ITEM: 14300 Lora Drive

Architecture and Site Application S-20-019

## **RESPONSE TO NEIGHBORHOOD**

### **ARCHITECT CONSULTANT RESPONSE:**

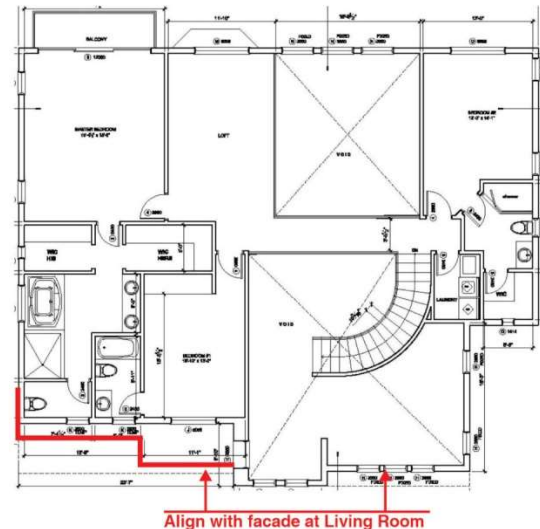
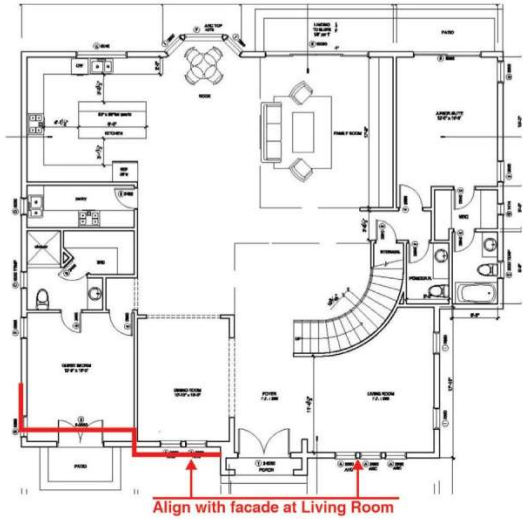
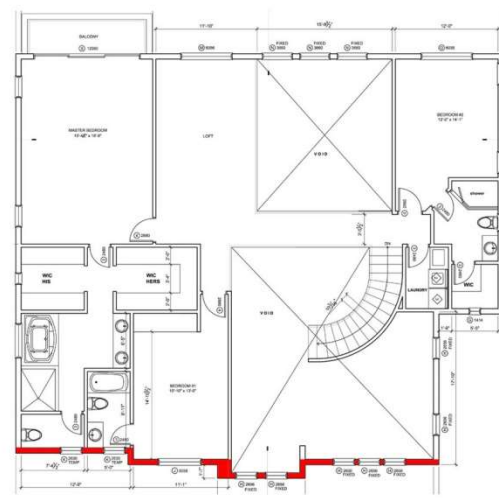
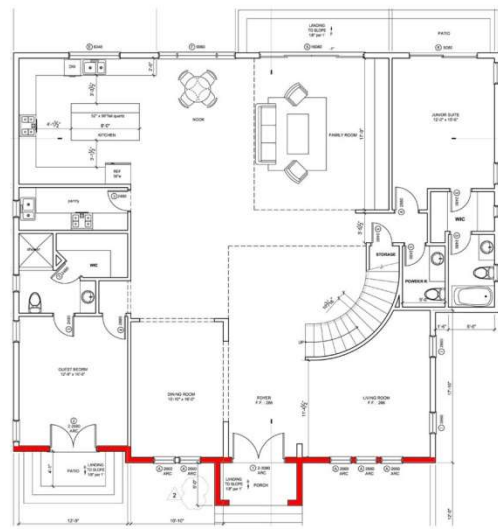
**1. Simplify the front façade form to allow a building envelope more typical of the formal Mediterranean Style.**

**Response:** The simplified front building envelope resulted into clearer and simpler architectural mass and manages to avoid complex roof forms to be consistent with Residential Design Guideline 3.3.1. (Develop the house plans and elevations together). The simplified front façade eliminates a more irregular front profile on the original design and also eliminates the need for first floor roofs which is inconsistent with the chosen Approach 2 (Formal Mediterranean Style). Some plan modification on the area that got affected by the changes resulted into a slightly larger GFA of 4,342 S.F. compare to the original of 4,195 S.F. that the owner has agreed to compromise in compliance to the Architecture Consultant recommendation. The increase GFA is reflected in Project Data on the revised Sheet A-1.

- Overall massing: 1' less overall massing height, with Level 1 height got reduced from 11' to 10' to create a less bulky massing and better proportion.
- Simpler architectural mass.

- Elimination of first story roofs to avoid complex roof.
- More uniform windows height and style.
- Projecting Porch massing also got increased to create more prominent entrance as an important central axis of the Formal Mediterranean Style (refer to Left/Right Elevation for clarity).

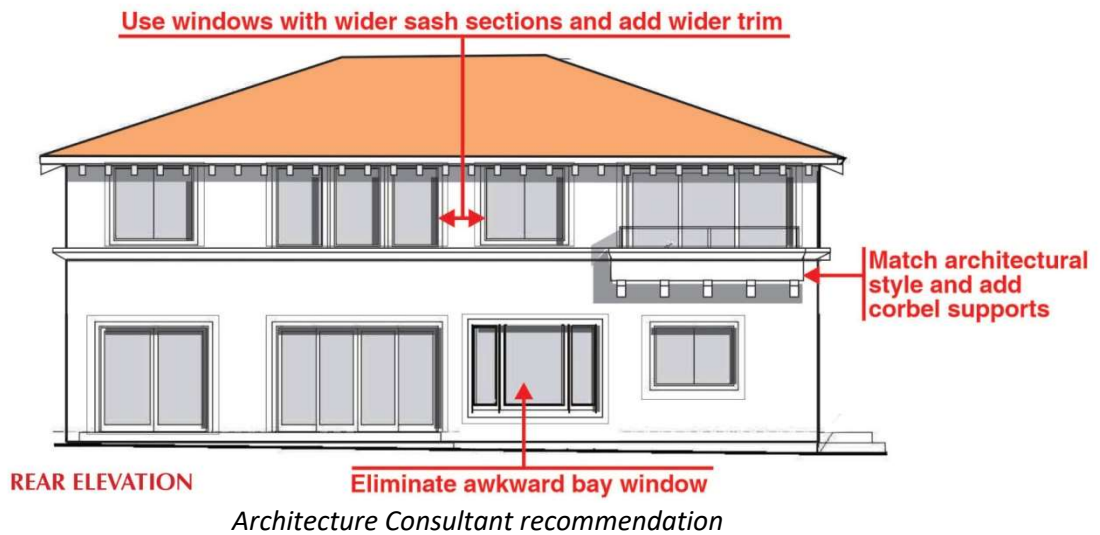
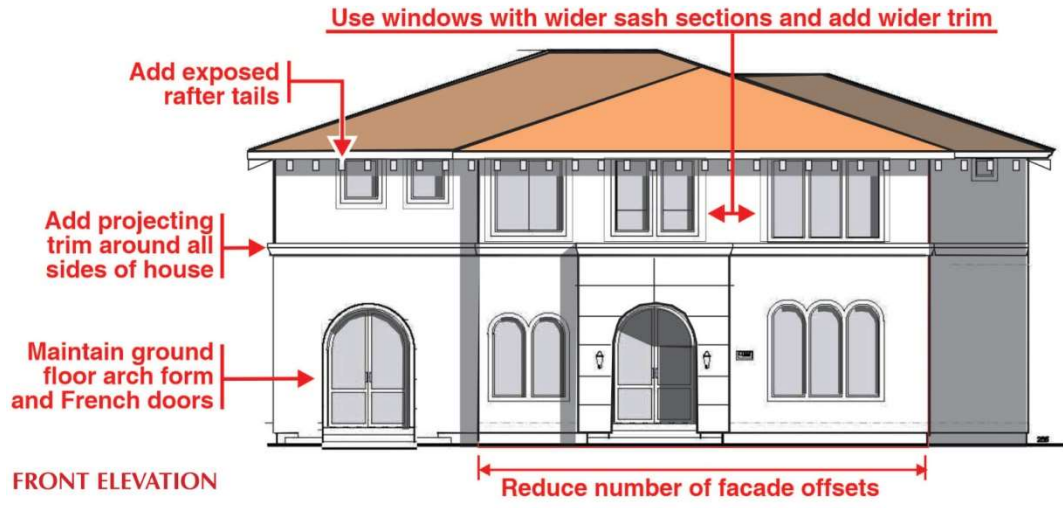
**2. Select windows with substantial sash and wood or cast stone trim width to match traditional windows appropriate to the style.**

**Response:** All windows sash (from 1.5" to 2.5") and trim width (from 3" to 6") has been substantially increased as reflected in all our revised elevations to match the intended architecture style and consistent with Residential Design Guideline 3.2.2. (Design for architectural integrity) and 3.7.4. (Design the windows with attention to matching the traditional details of the architectural style).

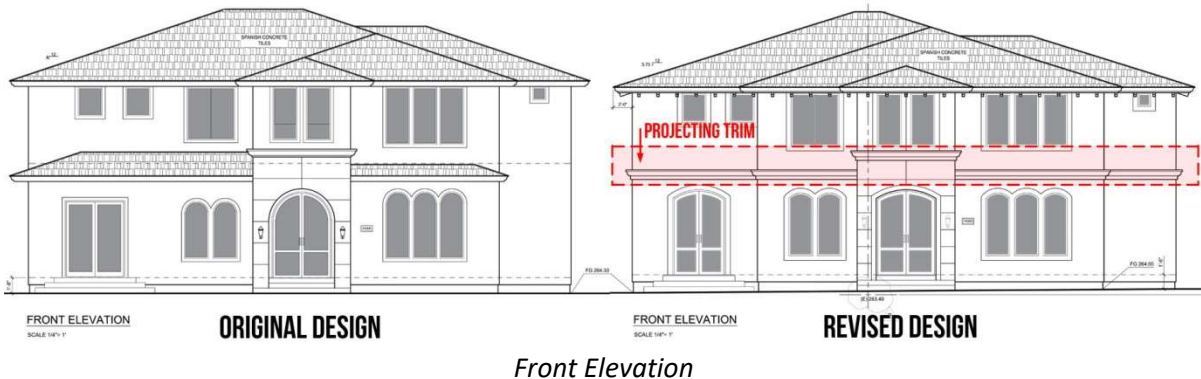
**3. Provide cast stone projecting trim below second floor windows on all four sides of the house.**

**Response:** A suitable profile projecting trim is added below second floor windows on all four sides of the house to provide visual relief for two story walls which is especially common in Formal Mediterranean Style. The added element is also responsive to Residential Design Guideline 3.3.3. (Provide visual relief for two story walls).

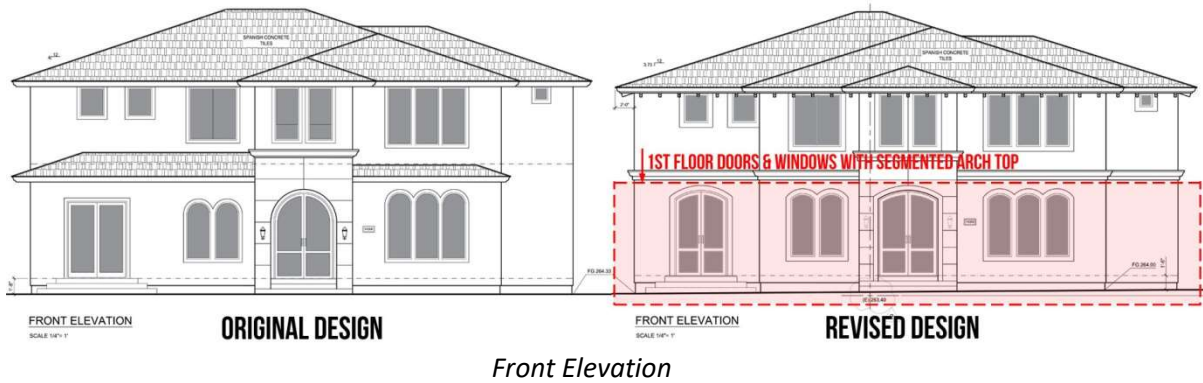
**4. Use arched window forms on all front elevation first floor windows and doors.**

**Response:** All front elevation first floor windows and doors have been modified with arched forms. We implemented 'segmented arch' top compare to the Architecture Consultant illustrated 'half arch' top, as it is aesthetically preferred by the owner. Knowing 'segmented arch' top is also common practice in Mediterranean Style. This implementation is consistent with Residential Design Guideline 3.2.2. (Design for architectural integrity).

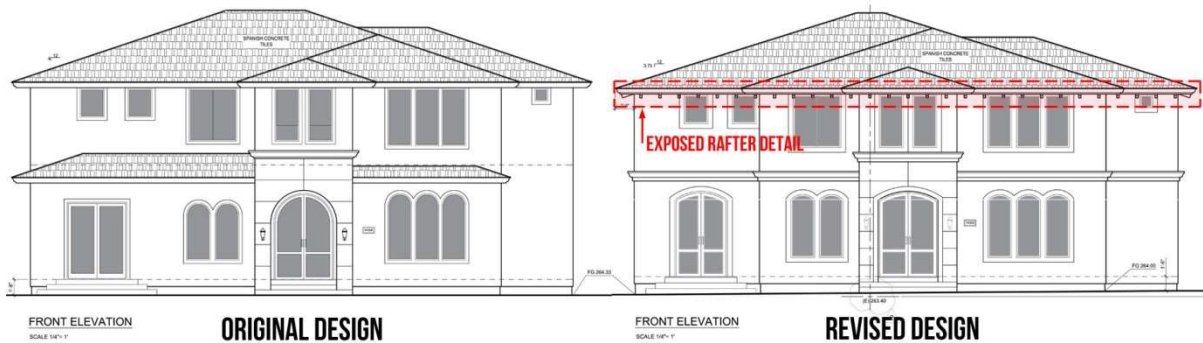
**5. Add exposed rafter tails at the roof eaves.**

**Response:** Rafter tails which are common practice in Mediterranean Style are added into the roof design. This implementation is consistent with Residential Design Guideline 3.2.2. (Design for architectural integrity).

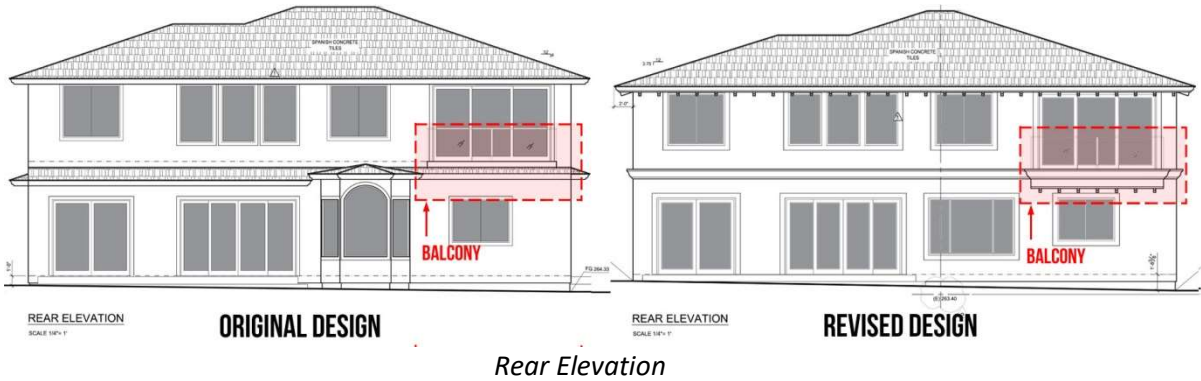
**7. Revise the design and supports for the second floor balcony to better relate it to the overall house design.**

**Response:** The design and supports for the second floor balcony has been revised to be consistent with the overall house design and style, with dimension that are large enough to clearly provide structural support for the balcony. This implementation is consistent with Residential Design Guideline 3.2.2. (Design for architectural integrity) and 3.10.2 (Balconies).

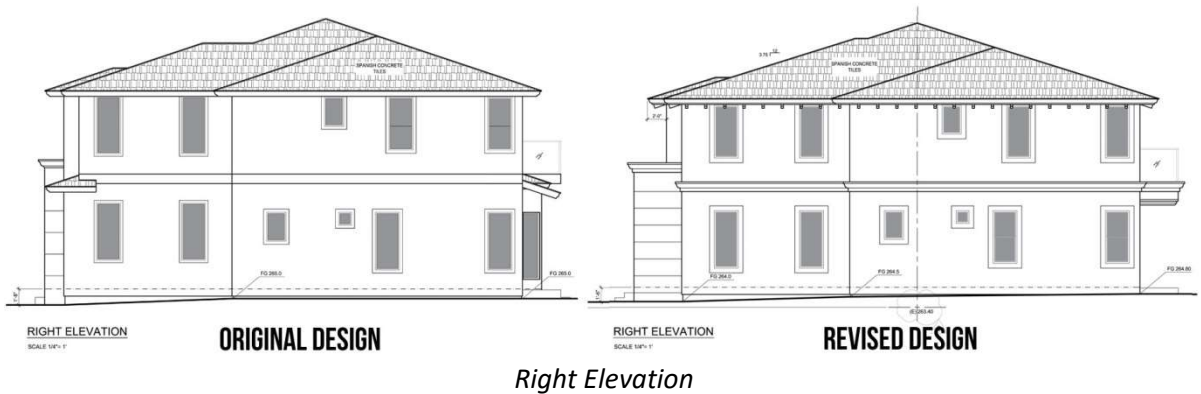
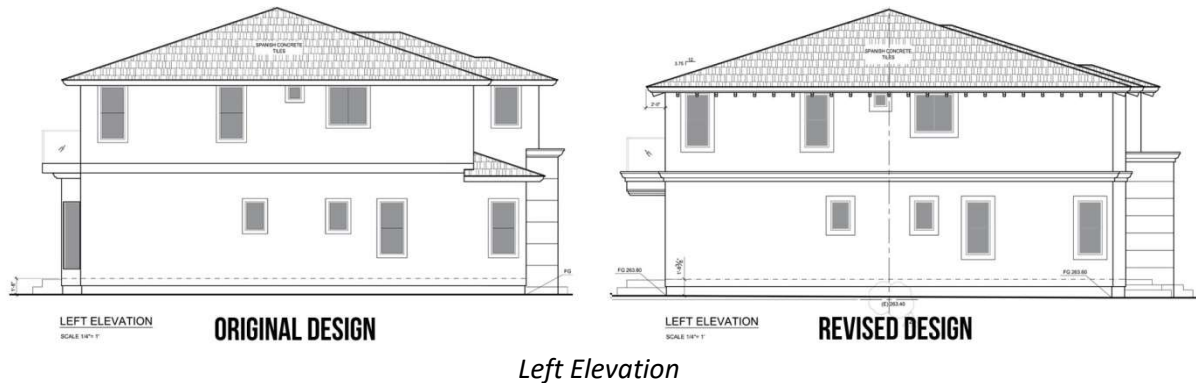
**8. Revise side elevation to match front and rear elevations.**

**Response:** Left and right elevations have been revised to be consistent with the front and rear elevations. This implementation is consistent with Residential Design Guideline 3.2.2. (Design for architectural integrity).
